Gatwick Airport Northern Runway Project

The Applicant's Response to Deadline 7 Submissions

Application Document Ref: 10.65

PINS Reference Number: TR020005

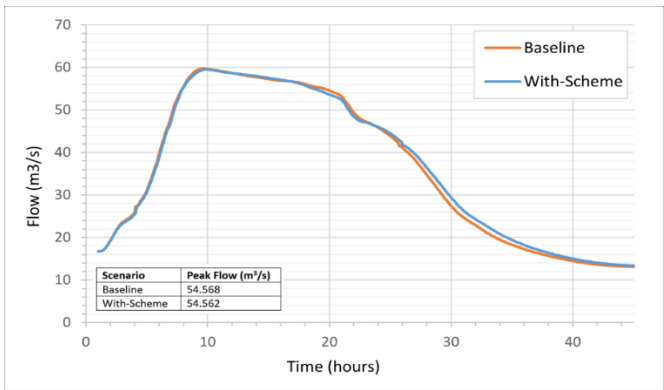
<p>Section 7 of the FRA contains information around the flood mitigation features to be included, with signposting given to ES Appendix 11.9.6: Annex 5 for some further outline details on the proposed Flood Compensation Areas (FCAs) at Museum Field and Car Park X. It is noted that the presence of the</p>	<p>Paragraph 6.2.13 of ES Appendix 11.9.6: Annex 5 Fluvial Model Build Report [REP5-027] indicates the increase in peak flows downstream of Car Park X FCA are likely due to the attenuation of the FCA to allow for the River Mole culvert to flow more efficiently, resulting in the increase in flows. However, this could not extend</p>

<p>FCA at Car Park X appears to increase peak flows downstream of this FCA. It is suggested the presence of the Museum Field FCA further downstream would capture this increase in flows so overall, the flood risk elsewhere would not be increased. It would be helpful to understand more about why the flows downstream would be subject to increase with the Car Park X FCA in place, and whether any measures can be incorporated into the design of the FCA at Car Park X to negate the suggested increase in flows.</p>	<p>further downstream beyond the Museum Field FCA and would not affect other parties as part of the holistic mitigation strategy for the whole Project.</p>
	<p>The FRA should also consider whether the introduction of the FCAs on the River Mole would result in any impact on flood peaks travelling further down the River Mole, especially after the confluence of the River Mole and the Gatwick Stream. As water will be attenuated in both Car Park X and Museum Field, is there likely to be any impact on the coincidence and timing of flood peaks from the Gatwick Stream and River Mole as they travel further along the River Mole downstream of the Airport?</p>	<p>The Upper Mole (UM) model has been used to determine the fluvial flood risk baseline and the potential impacts of the NRP. The model extends approximately 1.5km downstream of the NRP boundary which is considered sufficient to fully assess any potential downstream effects. Figures 7.2.3, 7.2.4, 7.2.5 and 7.2.6 in ES Appendix 11.9.6: Flood Risk Assessment [REP6-052] indicate the Project would not increase flood depths to other parties including those downstream. As an example, the hydrograph below demonstrates no increase to peak flows at minimal change to the timing of the peak in the River Mole at the downstream model boundary for the Credible Maximum Scenario.</p>

<p>Figure 2.1: Flow at the downstream boundary in the 1% AEP + 40% CC 12-hour event.</p>
	<p>The applicant should confirm if the failure of the proposed FCAs been considered and whether this has been considered in the Flood Resilience Statement in Appendix 11.9.6 Annex 6. It would be helpful to understand which structures have been included in the assessment of defence failure for completeness.</p>	<p>The width between the volume of stored water and the watercourse is approximately 70m and 100m for Car Park X and Museum Field, respectively. Therefore, these widths are significant and the FCAs are highly unlikely to fail and result in a sudden discharge of water into the receiving watercourse.</p>
	<p>Between 2029 and 2032, all the mitigation measures for fluvial flood risk would be completed though there are works which may result in a more localised risk to flooding, mainly associated with the highways improvements. Temporary compounds for</p>	<p>Section 10.7 of ES Appendix 5.3.2 Code of Construction Practice Annex 1 - Water Management Plan [REP3-020] includes construction-related design commitments to manage flood risk. For example, Paragraph 10.7.6 states that where river realignment is</p>
